Access Compliance Report

Public Rights-of-Way

(Pedestrian Signals)

Intersection ID: N/A	Main Street:	Cross Street: N/A	Location: N/A
ADA ID: 7346793DA33A	Signal Type: One Push Button-Non APS	Overall Compliance: No	Severity Score: BTN 1: N/A BTN 2: N/A No BTN: N/A
Codes/Mitigation Info/Possible Solution		Field Measurements/Component Compliance

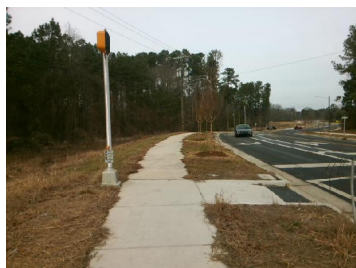
Possible Solutions: Replace Signal Push Button With APS Button on New Post. Remove & Relocate Sign.

PROW/ADA: TMUTCD 4e.08, R404.2, R404.3
